# CITY OF PORTLAND

# BUILDING PERMIT

Job ID: 2011-06-1249-ALTR

has permission to Replace rear deck and front sunroom/ seal foundation.

PLOT  
PLAN

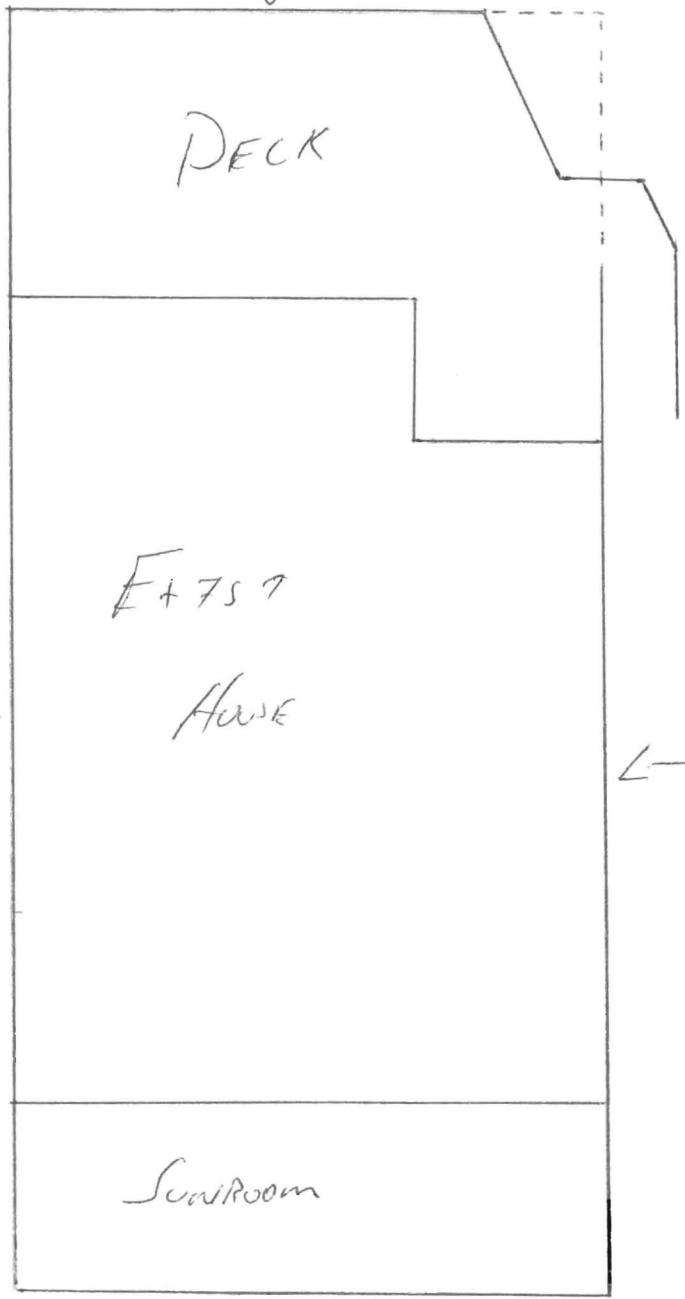
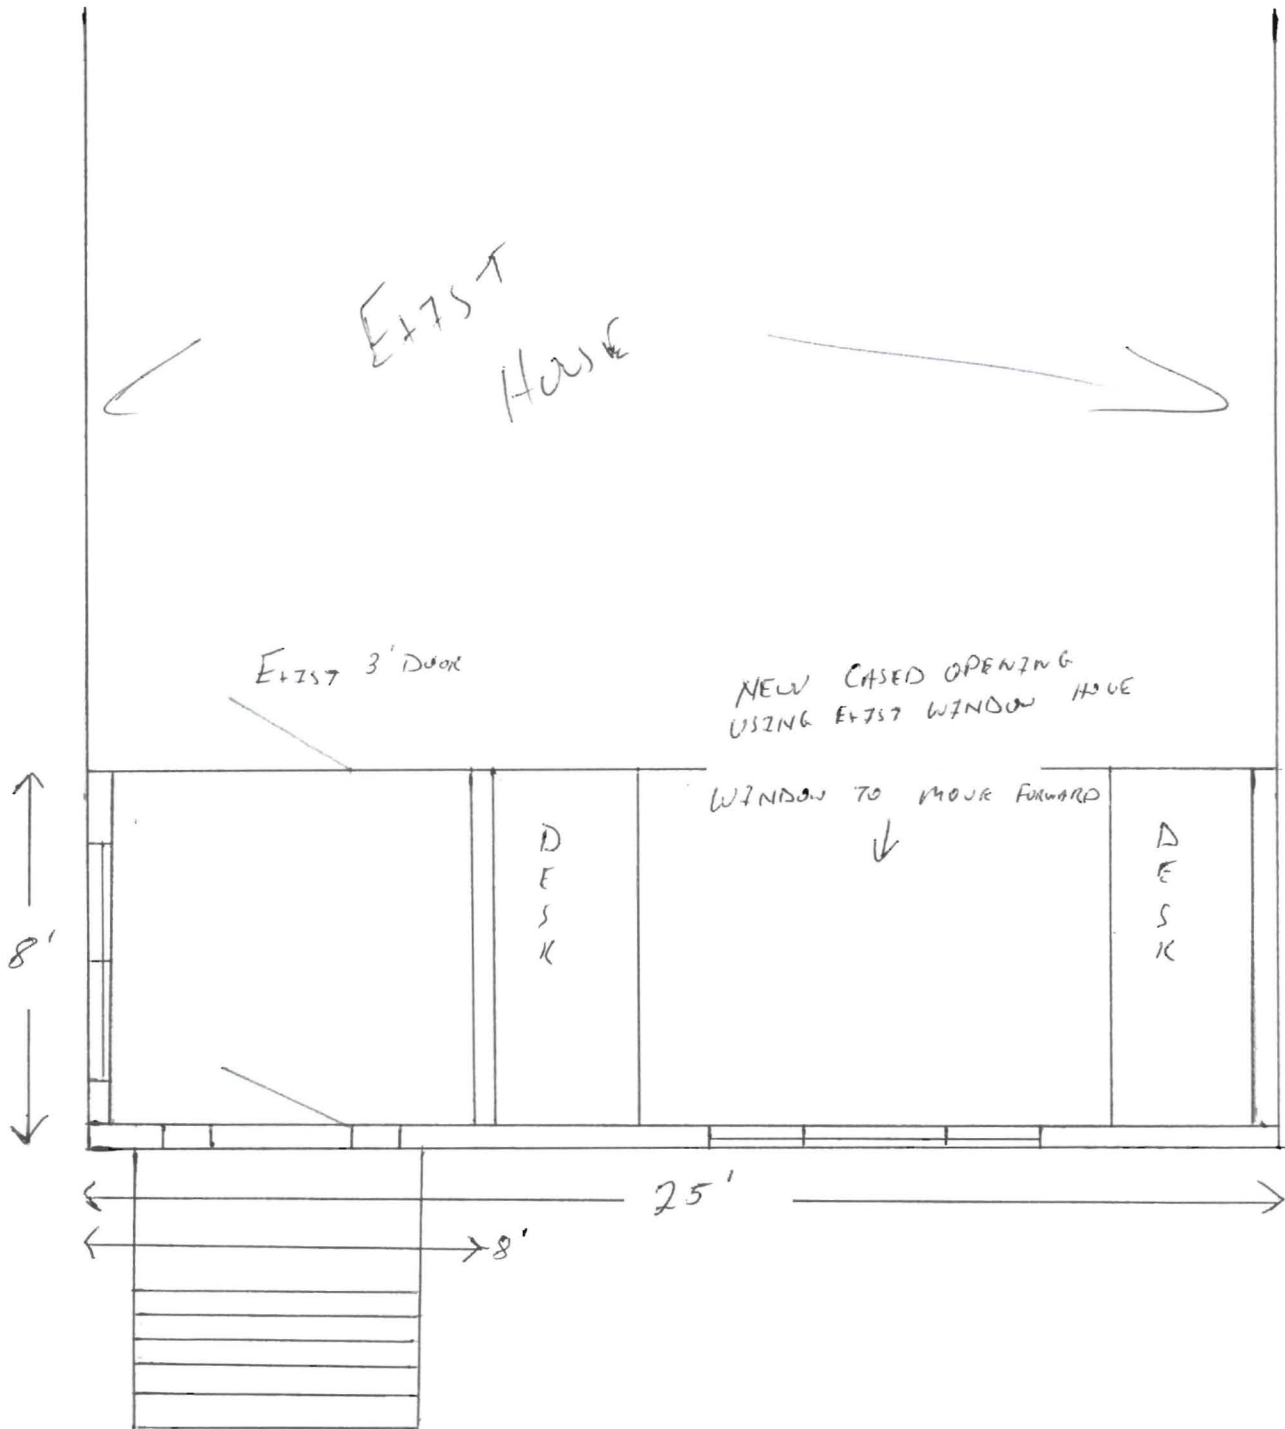
side - overhang - 8'

\* - 6' overhang <sup>see revised</sup>  
plus 612314

I have reviewed your permit application to rebuild the rear deck and front sun porch at 68 Codman Street. At this point I must deny your permit because the rear deck was not permitted, and it does not meet the required setback.

68 Codman is located in the R-3 residential zone. The minimum side setback for a one story addition is eight feet [section 14-90(d)(3)] . The distance given on the plot plan from the deck to the side property line is six feet. I researched our records to see if the existing rear deck had been permitted and it had not. If the deck was not permitted, it is not legal. Since it does not meet the side setback, it needs to be brought into conformity. You have thirty days to bring the deck into conformity. You may either revise the existing application to have the deck meet the eight foot side setback or you need to remove it.

1. This permit is being approved on the basis of plans submitted including the revised plans submitted June 23, 2011. Any deviations shall require a separate approval before starting that work.
2. This property shall remain a single family dwelling. Any change of use shall require a separate permit application for review and approval.
3. The existing rear deck was never permitted and it did not meet the side setback requirement. The plan has been revised using section 14-425 to allow a 6' x 2' part of the deck to remain within the setback. The overall width of the deck has been reduced two feet to meet the 8' side setback.

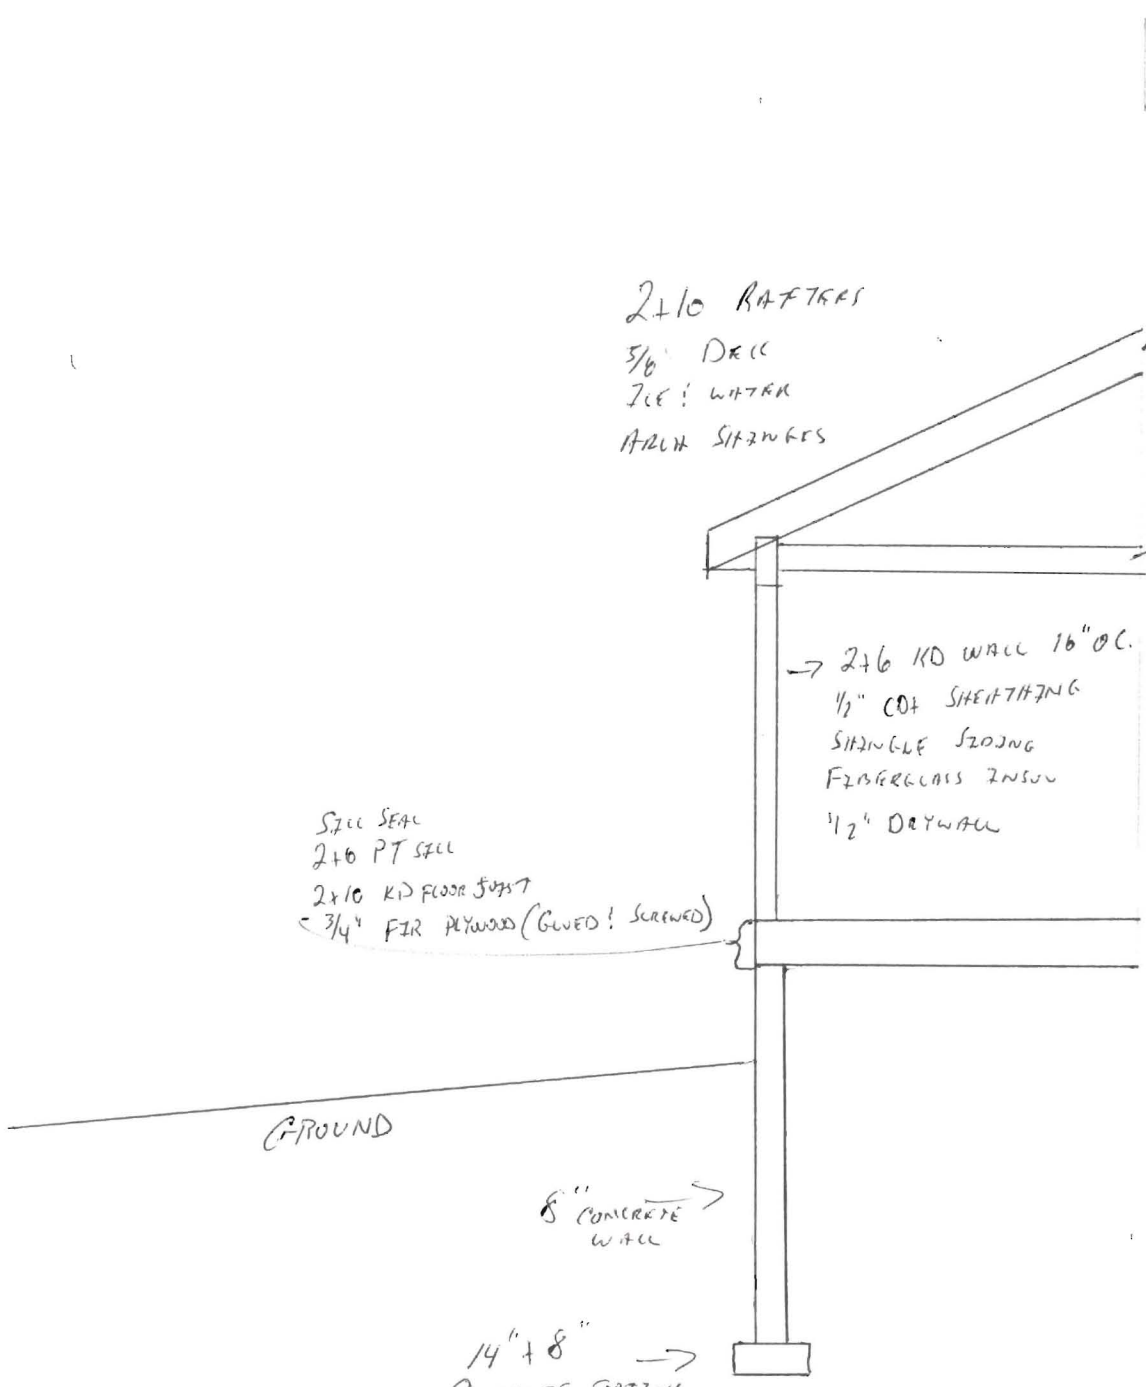
Approved  
hanger

1. Frost protection must be installed per the enclosed detail as discussed w/owner/contractor (at least 4' from grade).
2. Window sills in locations more than 72 inches from finished grade shall be a minimum of 24 inches above the finished floor of the room, unless a window fall prevention device is installed in accordance with section R612.3.

9. **R502.6 Bearing.** The ends of each joist, beam or girder shall have not less than 1.5 inches of bearing on wood or metal and not less than 3 inches on masonry or concrete except where supported on a 1-inch-by-4-inch ribbon strip and nailed to the adjacent stud or by the use of *approved* joist hangers.

PLOT PLAN

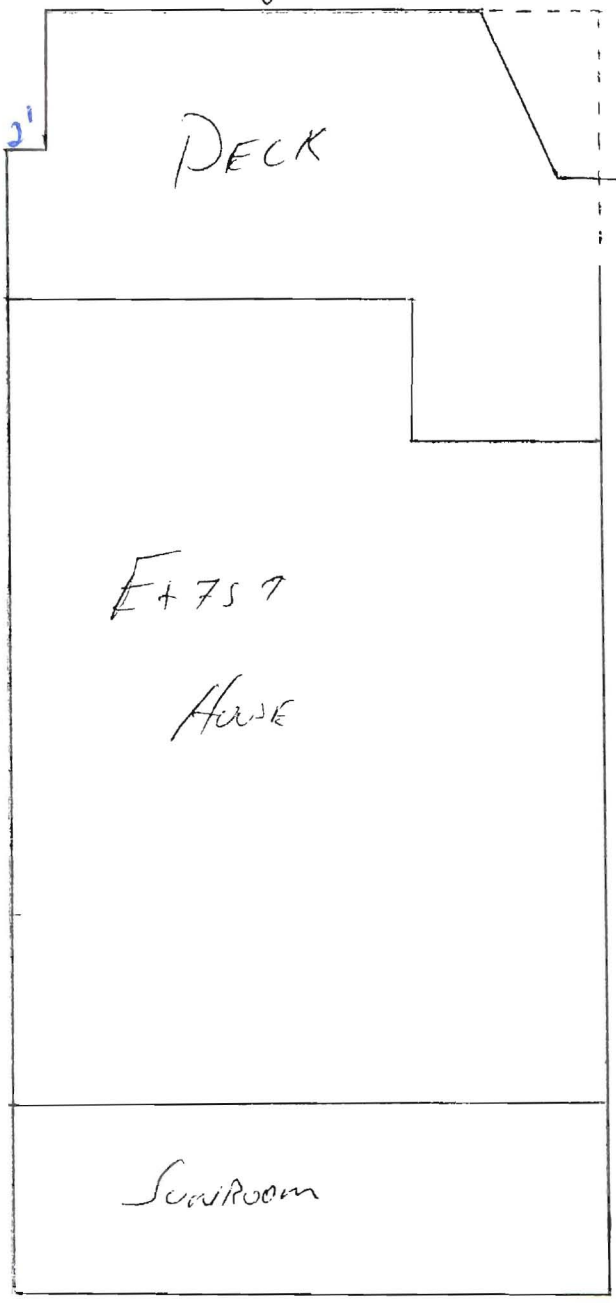
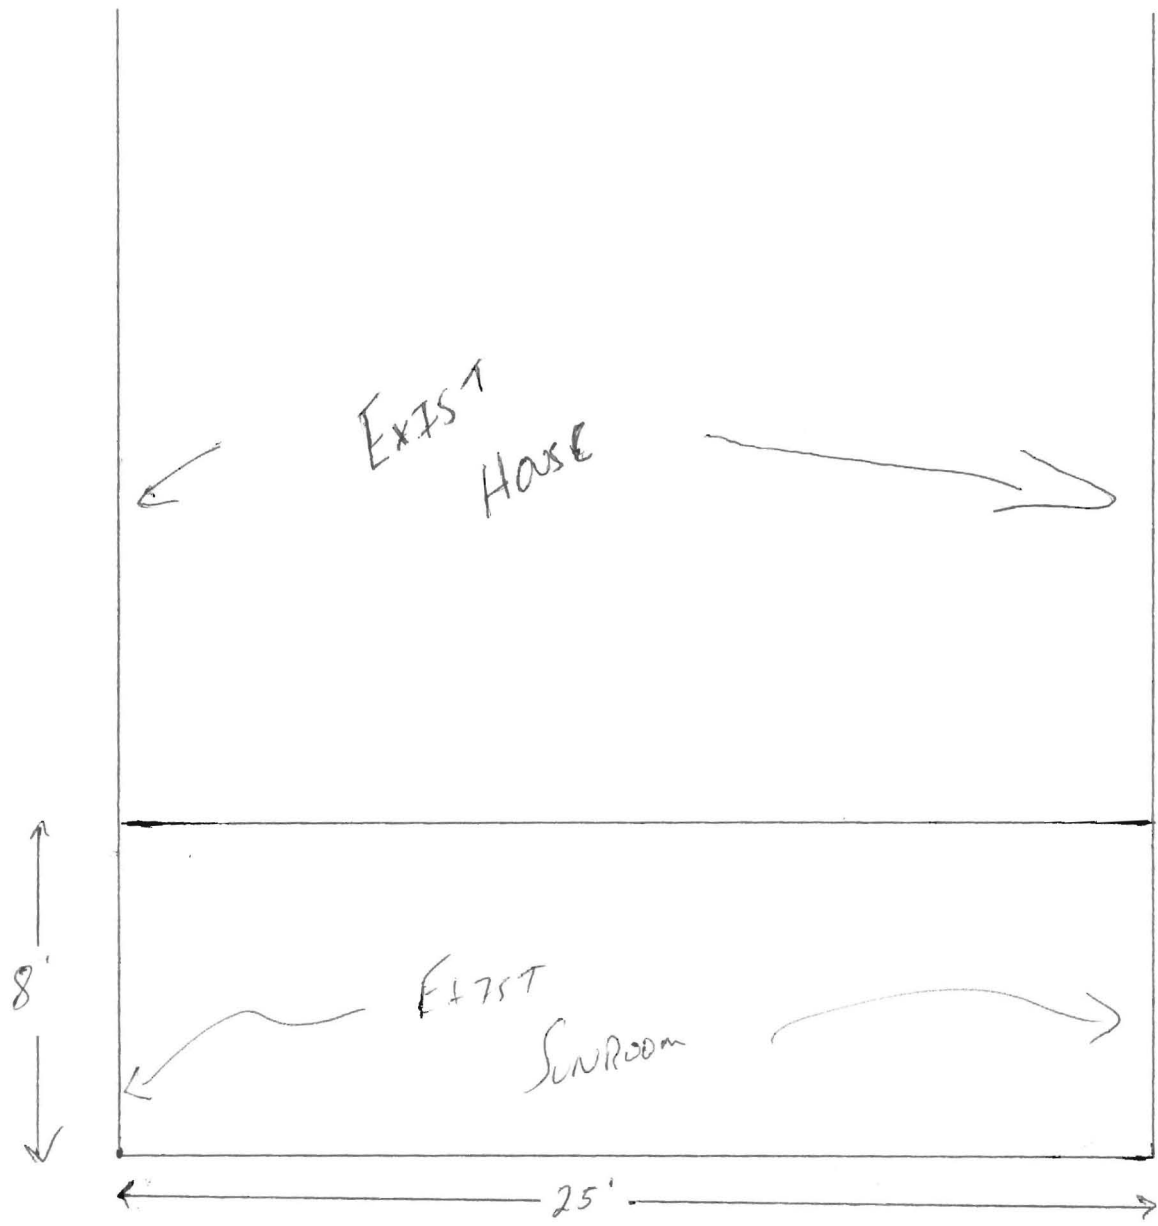
side - overhang - 8'

8' sizen  
- 6' sizen vs. 1/2 section  
14-425
